RE: Governor Printz Interceptor Project - Section I  
Contract No. 2010-01, Project No. 220612  
TRN 0174 Instrumentation Supplement to TRN 0121 – Station 209+75 to 212+75

**Re: Gov. Printz Interceptors – Sect. I**  
**Submittal Transmittal No. TRN0174**  
**Instrumentation Supplement**

**INSTRUMENTATION SUPPLEMENT TO TRN 0121**

**(Station 209+75 to Station 212+75)**

DEEP SETTLEMENT MARKER

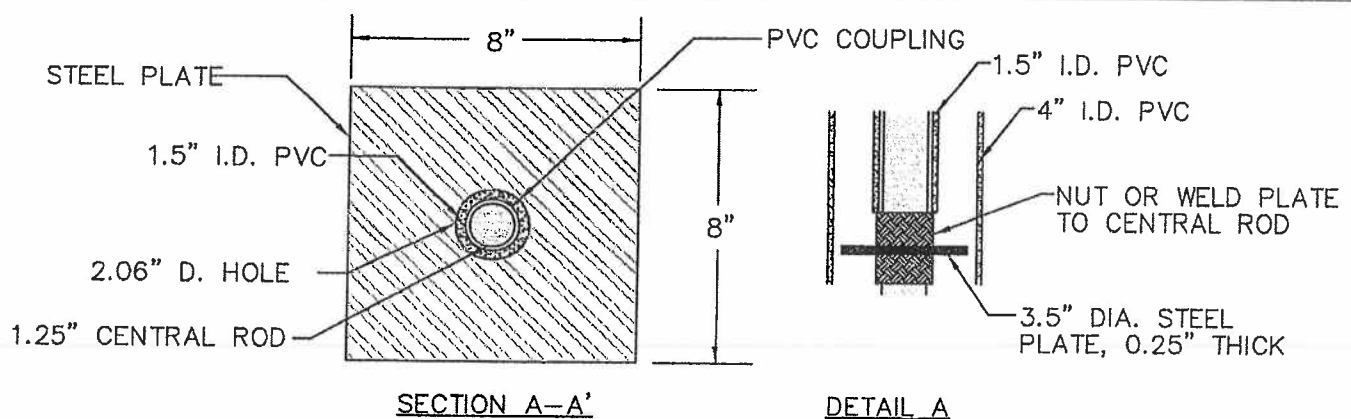
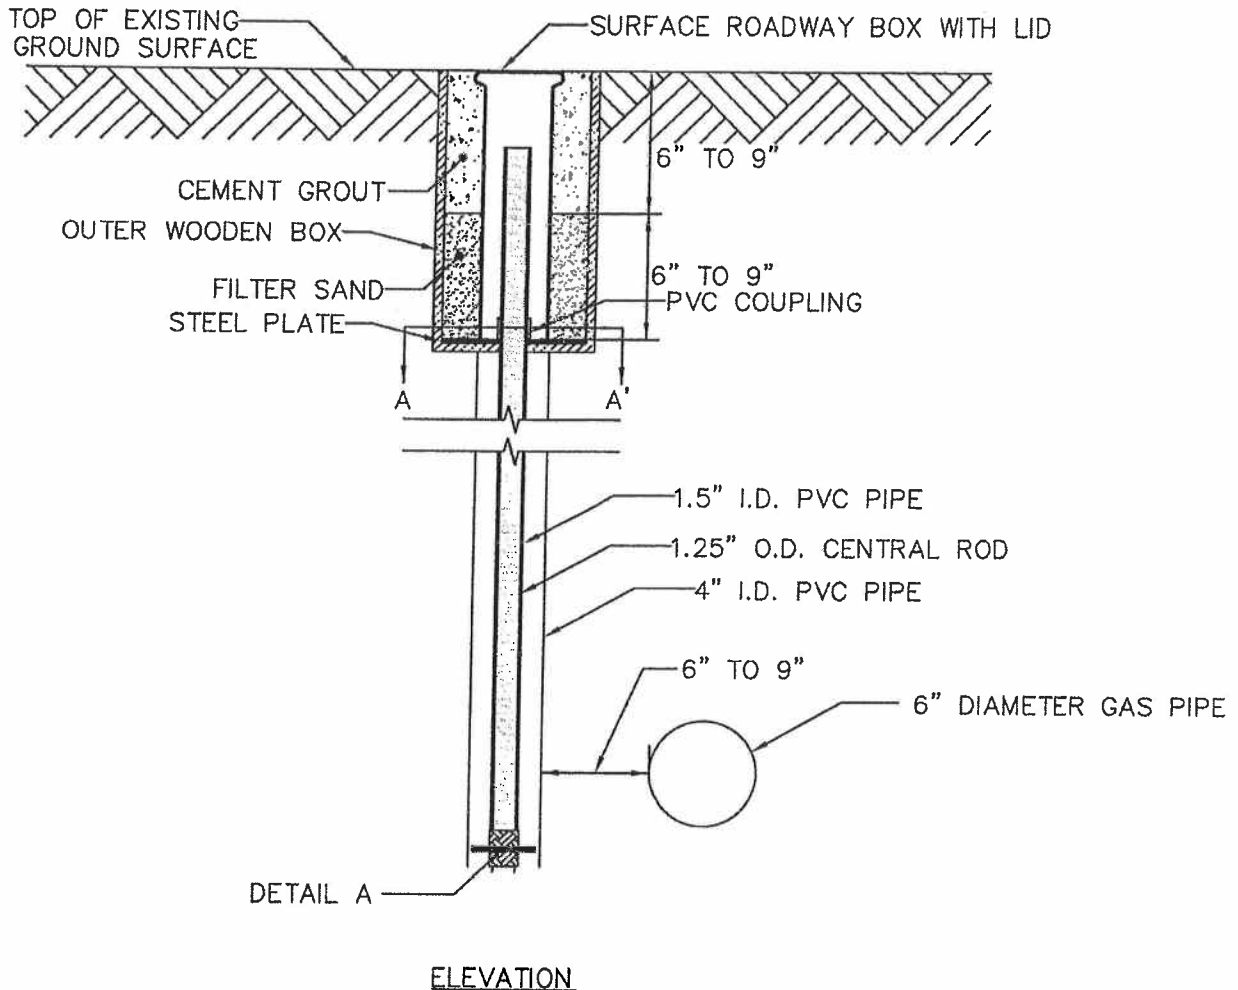
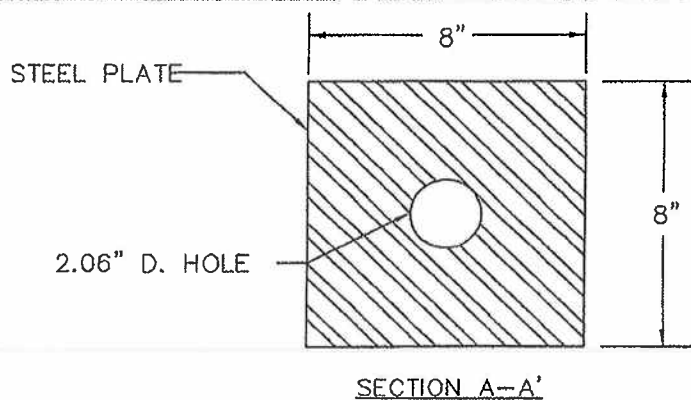
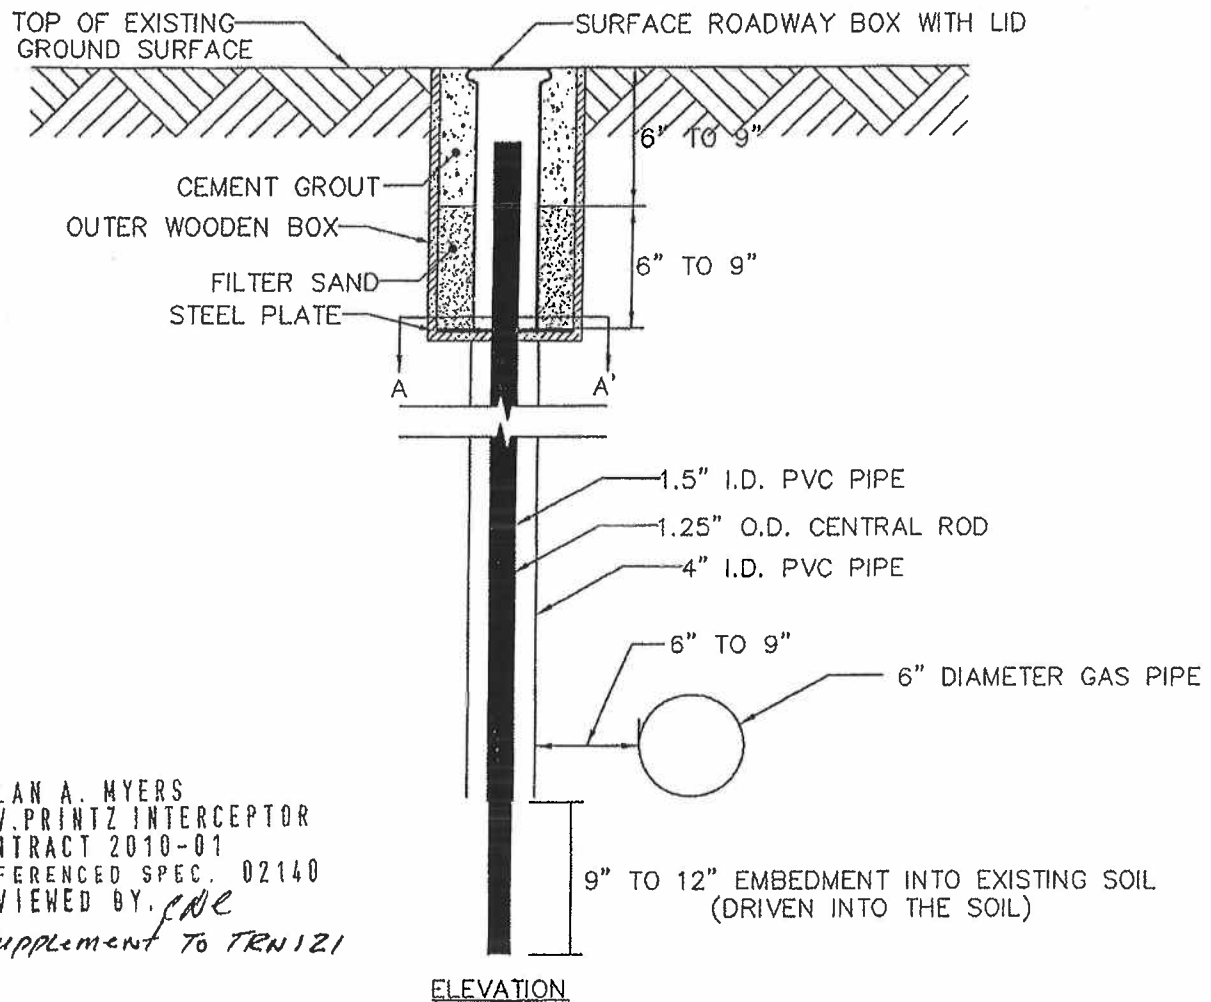
2. Direct monitoring of Gas Lines. AAM will coordinate the direct monitoring of the gas lines with Linde LLC.
3. Revised Ground Monitoring Detail. The detail to monitor for loss of utility ground support (Figure 2) has been modified based on the comments from PB. A revised Figure 2 is attached. The bottom of the monitoring point will bear at the invert level of the adjacent uppermost gas line.

3. **REVISED GROUND MONITORING DETAIL** -- AAM's revised plan detail to monitor for the loss of utility ground support (figure 2) is generally acceptable, except as noted. Ground monitoring points, currently and as proposed, are located between the two six-inch gas lines to provide the Contractor the maximum benefit of separation between the trench excavation and the potentially effected utilities. This was a previously agreed upon arrangement based upon the monitoring points being fixed in concrete at the approximate invert elevation of the uppermost pipe. The revised detail indicates the deep settlement markers will be driven into the soil, 9 to 12 inches below the invert level. Driven steel rod monitor points are acceptable, but they are typical fixed at a depth deeper than a 9-inch minimum – refer to  $\pm 3$ -foot driven depth on figure 12.10 of "Geotechnical Instrumentation for Monitoring Field Performance" by John Dunncliff (1993). Regardless of whether the monitoring points are driven or concreted in-place, the level of monitoring should be fixed no deeper than the invert of the uppermost pipe, as previously accepted, so that the monitoring point does not develop support below the trench excavation's potential zone of influence upon the utilities. In addition, shouldn't the central rod be showing a "stick-up" above the 1.5" I.D. casing? Please revise detail as appropriate.

This letter is in response to your June 22, 2012 letter and the revised "Deep Settlement Marker" detail received on June 25, 2012. The settlement marker detail (revised cdc 6-25-12) is acceptable, provided that the plate bearing at the invert elevation of the gas line is founded below the leading edge of the casing, so as to be free to move independently of the casing and any soil plug formation therein (refer to Annotated Figure 2 attached). Given that settlement monitoring points are normally anchored in the ground (driven, spiral foot, concrete, etc.), PB questions whether the free-floating rod detail as proposed by AAM is an improvement over the fixed concrete encased monitoring point detail in the previously accepted submittal TRN 0121. However, in an effort to compromise and move the project forward, PB will accept the revised re-submittal subject to above and the comments provided in its June 14, 2012 response to AAM (the "June 14 Response").

## UTILITY MONITORING POINT

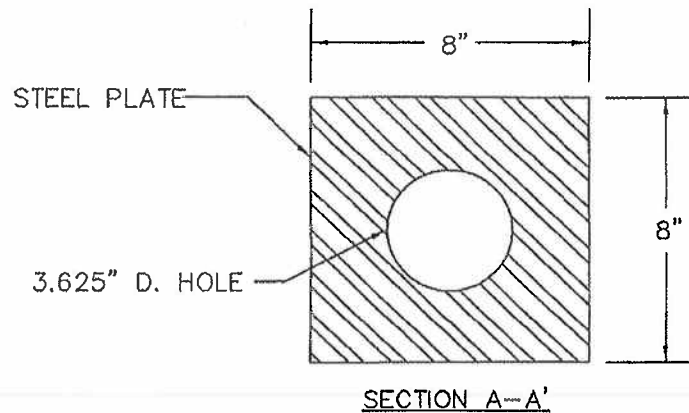
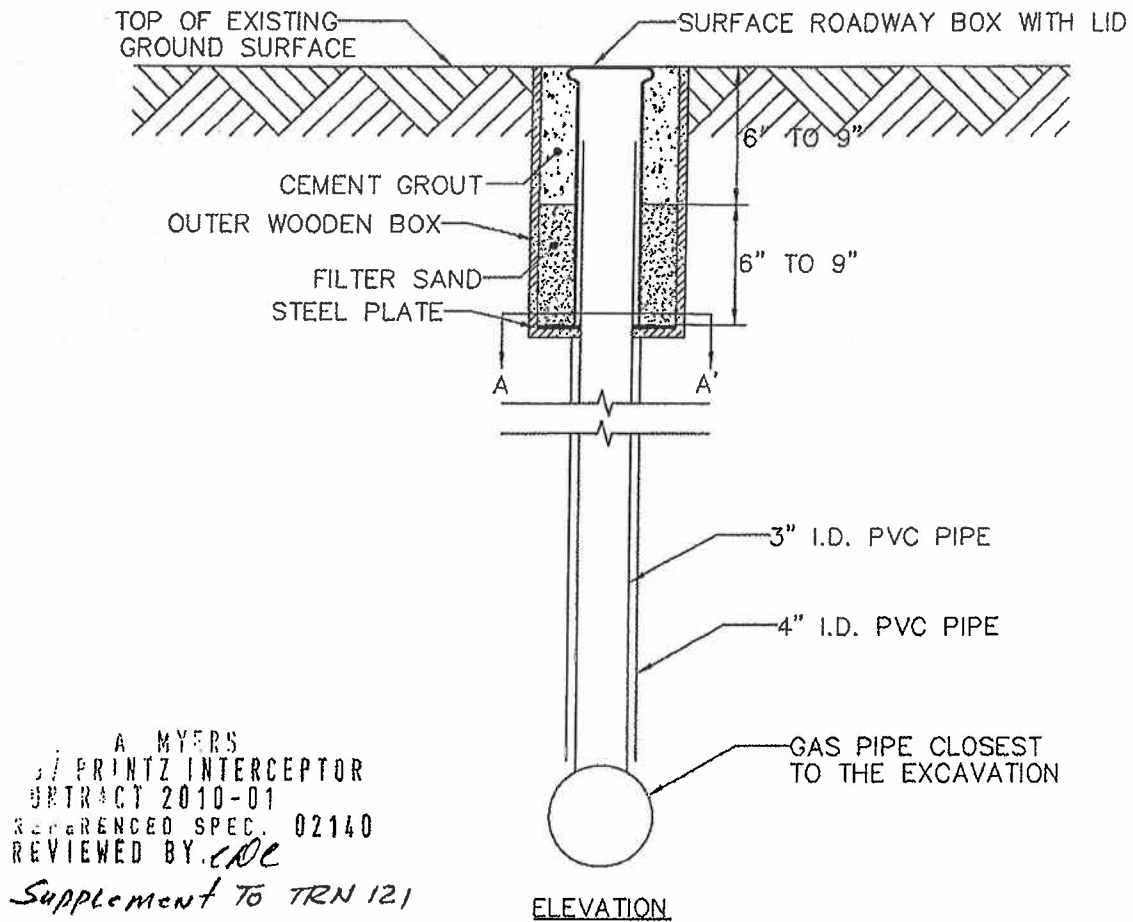
2. **DIRECT MONITORING OF GAS LINES** -- AAM's plan detail to directly monitor the utility pipe closest to the excavation (figure 1) is acceptable, pending AAM's coordination with the governing utility company – in this case Linde LLC. NO RESPONSE REQUIRED.
